Subject: TRIMMED Submi ion re 15 Ocean Road, Palm Beach

RE: DEVELOPMENT APPLICATION DA (DA2023/1532) PROPOSED NEW DWELLING WITH SWIMMING POOL 15 OCEAN ROAD, PALM BEACH

Image 2: Upper level terrace private open space

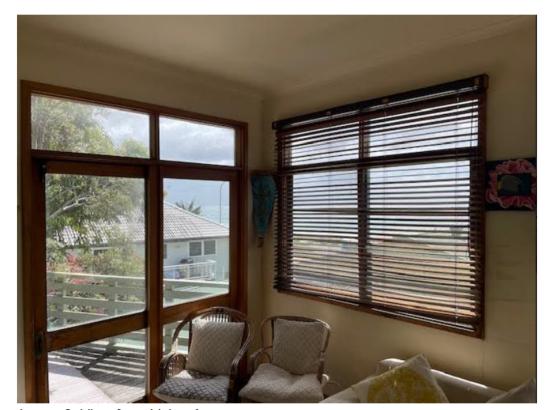
The proposal is grossly non-compliant with height, building envelope and number of storeys that it could not possibly be reasonable for my client to lose highly valuable water views. Images are provided of the view from No. 16

These highly valuable and expansive views will be directly impacted by significant non-compliances which is unreasonable. Until height poles are erected the full extent of the impact cannot be understood however I refer to step 4 of the view sharing planning principle which states:
